STAFF SUMMARY REPORT (John Madigan)  
MEETING DATE: July 12, 2017

**SUBJECT:** **Lehigh Southwest Cement Company and Hanson Permanente Cement, Inc., Permanente Plant, Cupertino, Santa Clara County – Amendment of NPDES Permit and Cease and Desist Order**

**Revised Tentative Order No. R2-2017-00XX**

**Amendment of Order No. R2-2014-0010  
(NPDES No. CA0030210)  
for Lehigh Southwest Cement Company and  
Hanson Permanente Cement, Inc.,  
Permanente Plant  
Cupertino, Santa Clara County**

ATTACHMENT 2 – FACILITY MAP

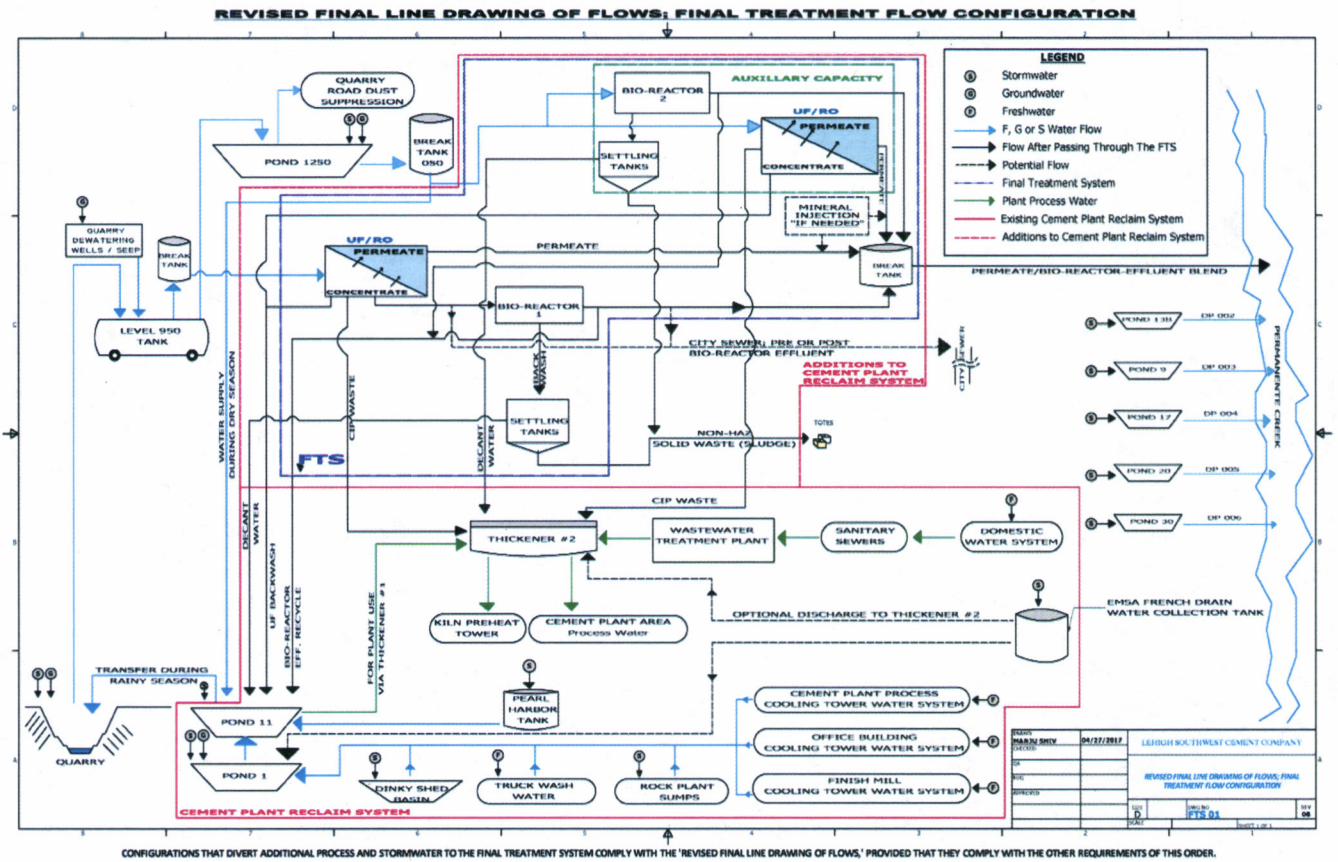
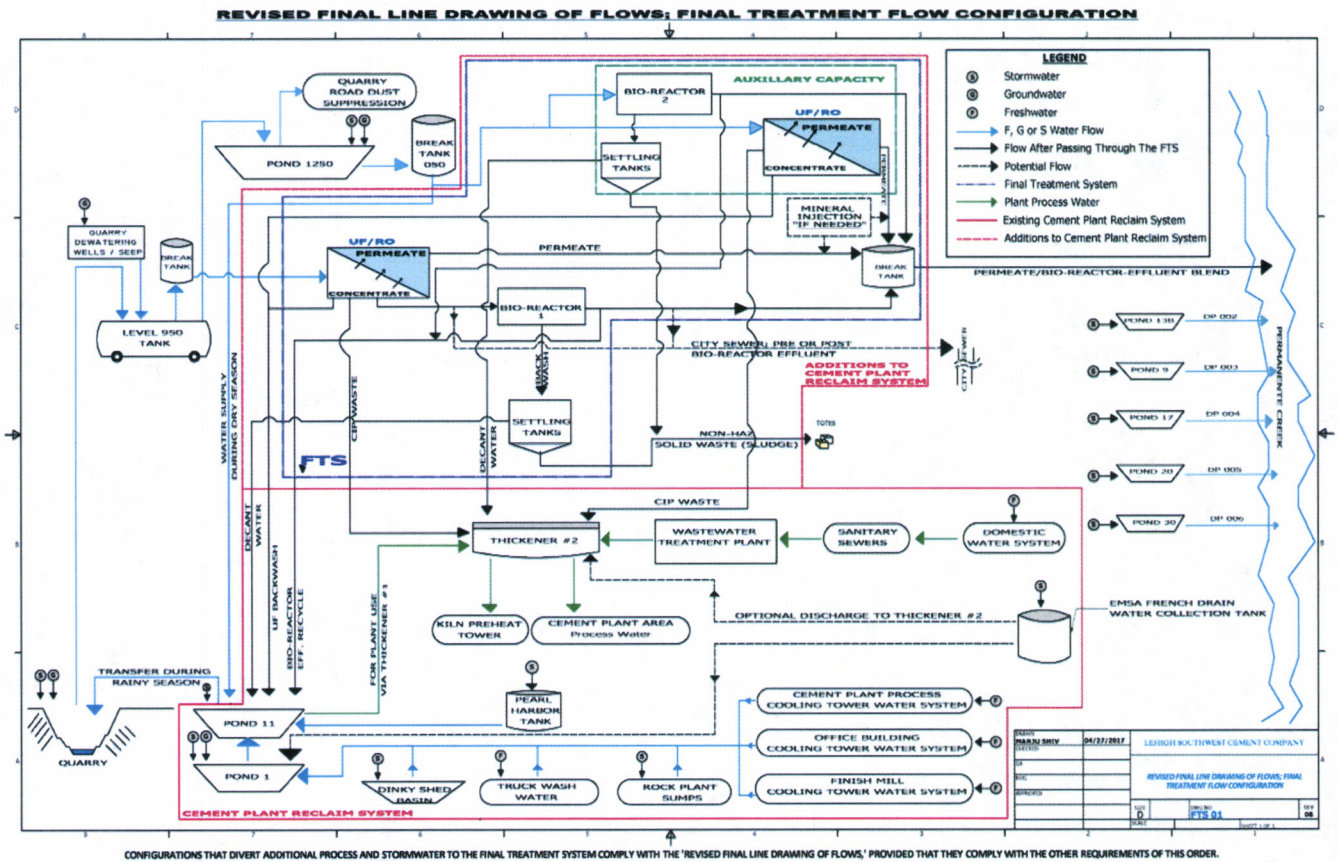
**Sierra Club Comment 1:** *Sierra Club objects to the relocation of Discharge Point No. 001 from Pond 4A to the new location approximately one mile downstream. It notes that Lehigh's mining operations depress the groundwater gradient, drawing water from Permanente Creek into the quarry pit. Thus, a significant portion of the flows treated by the final treatment system (and discharged at Discharge Point No. 001) comes from water formerly in the creek at higher elevations. Sierra Club requests that treated water be discharged to approximately the same location and elevation where it was removed.*

**Response:** We agree that some of Lehigh's discharge may be necessary upstream to support Permanente Creek aquatic habitat beneficial uses prior to filling the pit and restoring the creek. We revised the tentative orders (1) by revising the definition of Discharge Point No. 001 to authorize discharge throughout the stretch of Permanente Creek adjacent to the Lehigh site, and (2) by adding a permit provision requiring Lehigh to determine the minimum flows needed to protect existing aquatic habitat beneficial uses and to provide those flows as necessary.

Finally, we revised the Facility Maps (Attachment 2 of the tentative permit amendment and Attachment 1 of the tentative CDO amendment) to include the following text:

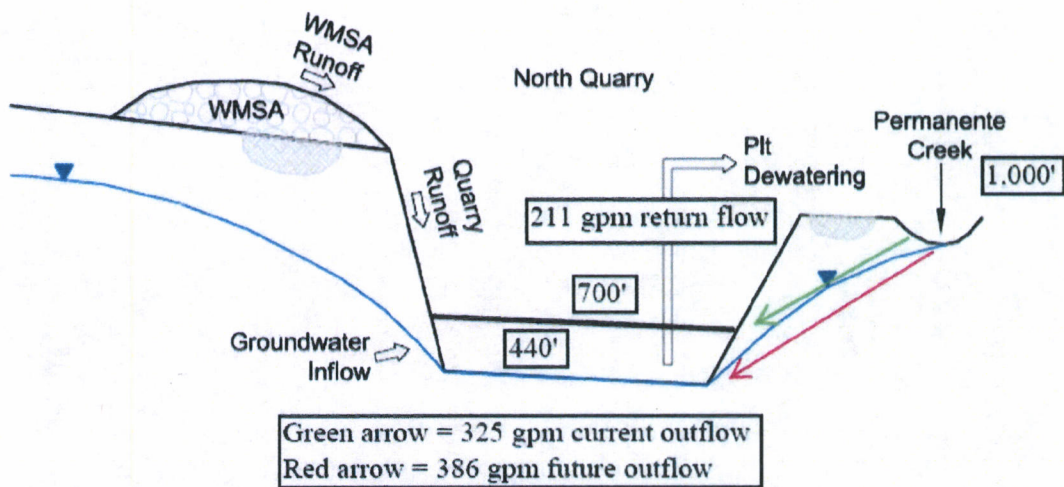
Lehigh seeks to change the FTS discharge point in its NPDES permit from Pond 4A, at an elevation of ~1,080 feet, to a new location approximately one mile downstream at an elevation of ~500 feet. Lehigh letter to Regional Water Board, December 30, 2016. The requested change in location appears to be inspired by an interest in lowering pumping costs.

Lehigh's request should be rejected; Lehigh's current Pond 4A discharge point should be retained. That point, shown in relationship to the Lehigh quarry, is shown below.

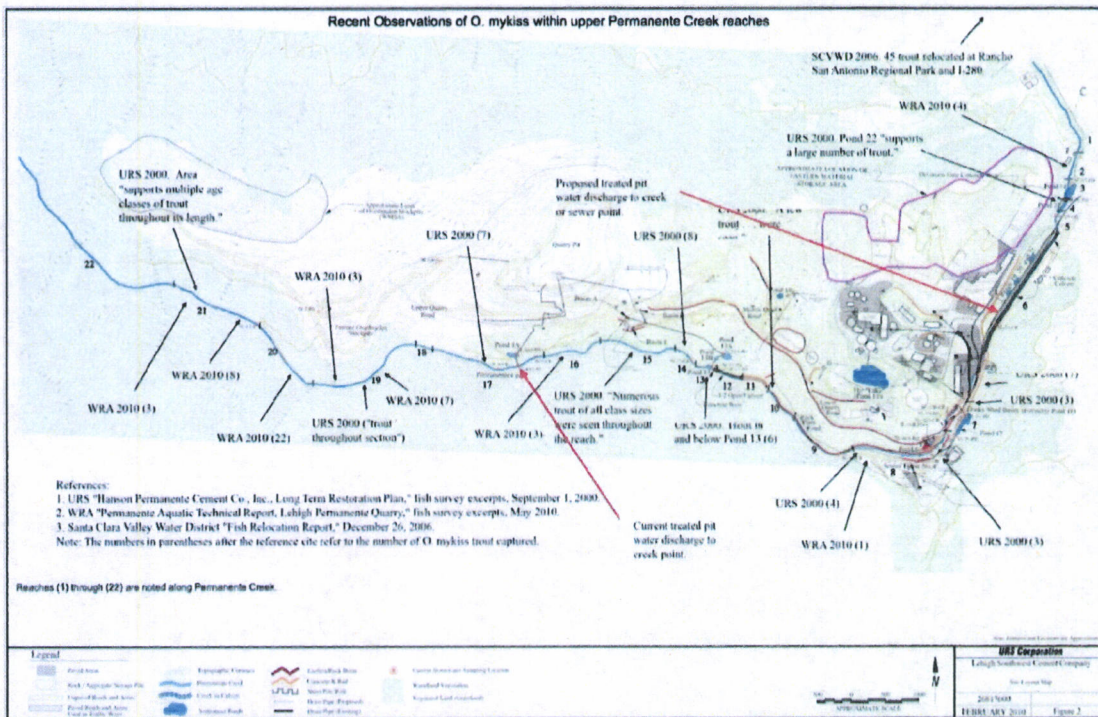
A graphic explaining how creek drawdown from pit dewatering is at least partially counter-balanced by the re-introduction of treated pit water, is shown below:

To what extent would Permanente Creek be deprived of FTS treated water return flows if Lehigh's request to change the point of discharge from Pond 4A to the cement plant location? The map below indicates at least a mile of creek would be adversely affected. Not only would resident fish be harmed by this significant reduction in flow between Pond 4A and the cement plant, but all related species and riparian habitats.

REVISED FINAL LINE DRAWINGS OF FLOWS: FINAL TREATMENT FLOW CONFIGURATION

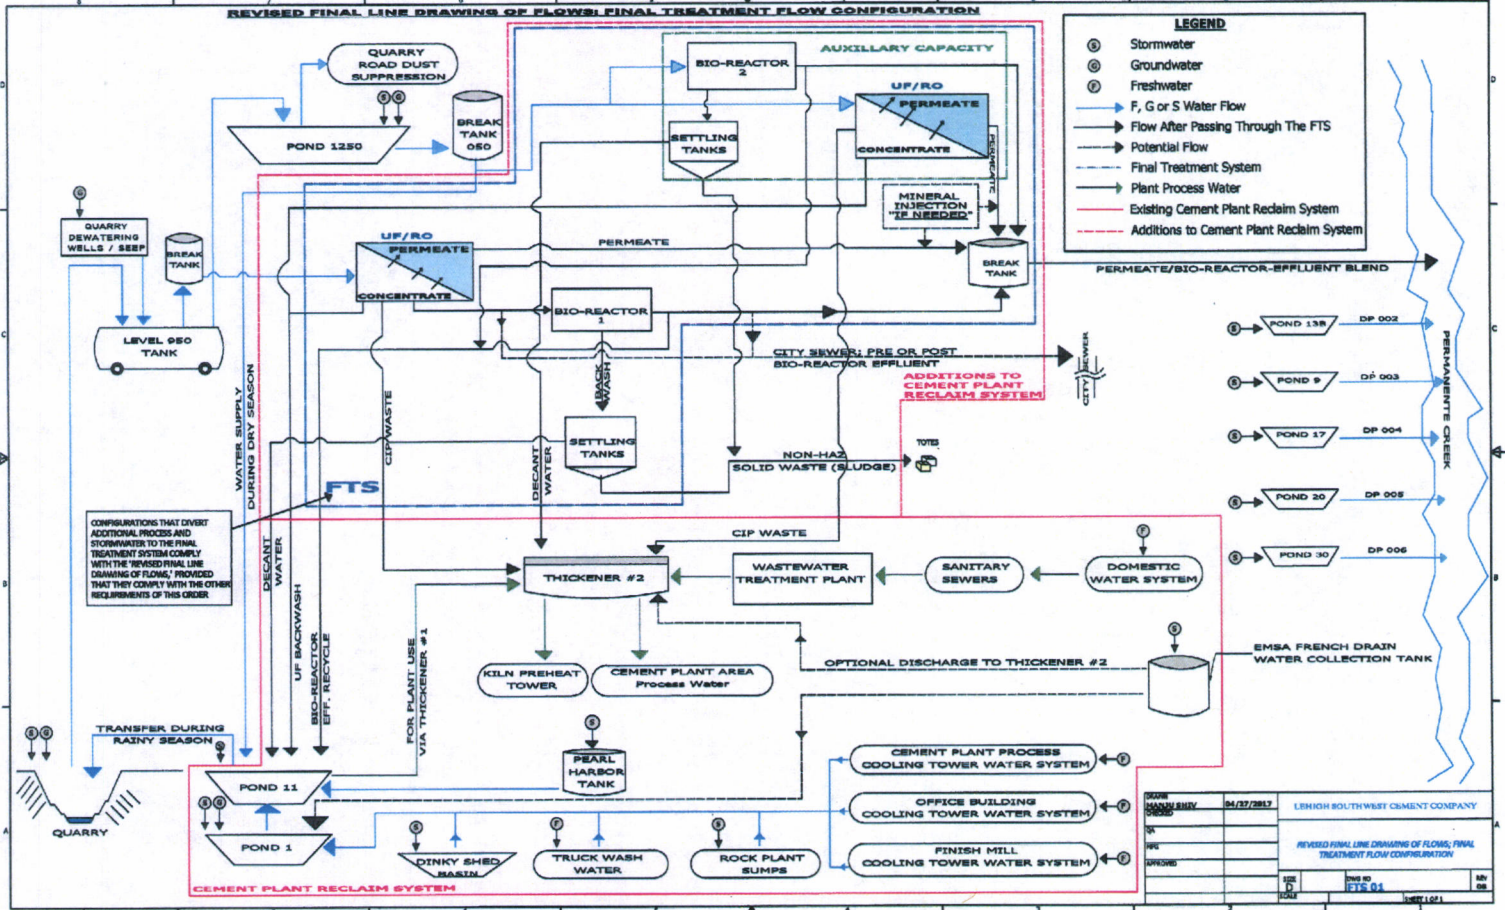
1 | Thank you for the opportunity to comment. Lehigh noticed that the "Pearl Harbor" tank was inadvertently omitted from  
2 | the final flow configuration line drawing, and submits a revised figure here, with Pearl Harbor noted (as a source of  
storm water flows within the Cement Plant Reclaim System), simply for accuracy (no substantive change). Further,  
Lehigh now has more exact coordinates from which it plans to sample EFF-001 (Table E-1), page 4 of the permit  
amendment (N 1942091.8, E 6099830.2), please let us know if you would like further details for inclusion in the  
documents prior to the Regional Water Board hearing.

**Lehigh Comment 1:** *Lehigh comments that the "Pearl Harbor" tank was inadvertently omitted from the Revised Final Process Flow Diagram and submitted a revised diagram. Lehigh notes that the Pearl Harbor tank is a source of stormwater flows within the Cement Plant Reclaim System, and that adding the label is not a substantive change but is necessary for accuracy.*

**Response:** We agree. We revised the Revised Final Process Flow Diagrams (Attachment 3 of the tentative permit amendment and Attachment 2 of the tentative CDO amendment) to include the Pearl Harbor tank.
